"HULL TRADER"

Nature of Survey

2nd. S.S. No. 3.

THICKNESSES OF PLATING ascertained by drilling, and comparison of same with the original thicknesses.

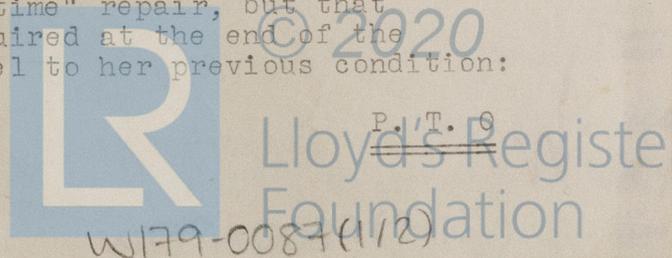
A number of shell plates amidships in D, E, F, G, H, J, and K strakes (fitted with welded patches) and slightly buckled frames etc. in way.

The shell plating has been drilled, with results as shown above which appear to be satisfactory.

It is submitted the vessel appears worthy to remain as classed with record of survey 12.40 and notation of S.S. No. 3-12.40, subject as above, to shell plating amidships in D, E, F, G, H, J and K strakes and frames ^{etc.} in way being dealt with, to 15 fathoms of chain cable being supplied at the first opportunity (and to 30 fathoms of chain cable being supplied when the present state of emergency has passed).
